Safety Recall: Fuel Pump Relay May Cause Engine No-Start or Stalling

The repair is to check the name printed on the fuel pump relay. If the name is DENSO, the relay doesn't need to be replaced. If the name is MITSUBA, replace the relay if the vehicle is shown as eligible on a VIN status inquiry. For repair, affected vehicle, and warranty information, refer to Service Bulletin 07-020, *Safety Recall: Fuel Pump Relay May Cause Engine No-Start or Stalling*.

DENSO RELAY
 (Do not replace.)

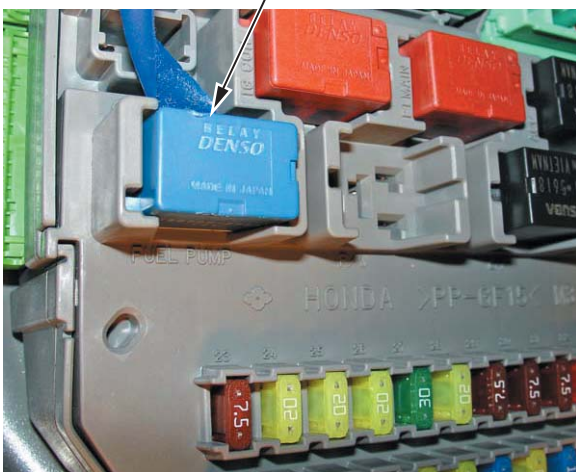
- If the name is **DENSO**, the relay is OK. Go to step 6.

- If the name is **mitsuba**, and the vehicle is **not** shown as eligible on a VIN status inquiry, go to step 6.
- If the name is **mitsuba**, and the vehicle is shown as eligible on a VIN status inquiry, go to step 4.

NOTE: MITSUBA may be printed upside down.

MITSUBA RELAY
 (Replace it if the vehicle is shown as eligible on a VIN status inquiry.)

4. Remove the relay.
 NOTE: Since the relay will not be reused, it's OK to remove it with pliers.
5. Press the new relay into place on the fuse/relay box.
6. Reinstall the left kick panel and the left front door sill trim.
7. Center-punch a completion mark above the 17th character of the engine compartment VIN.
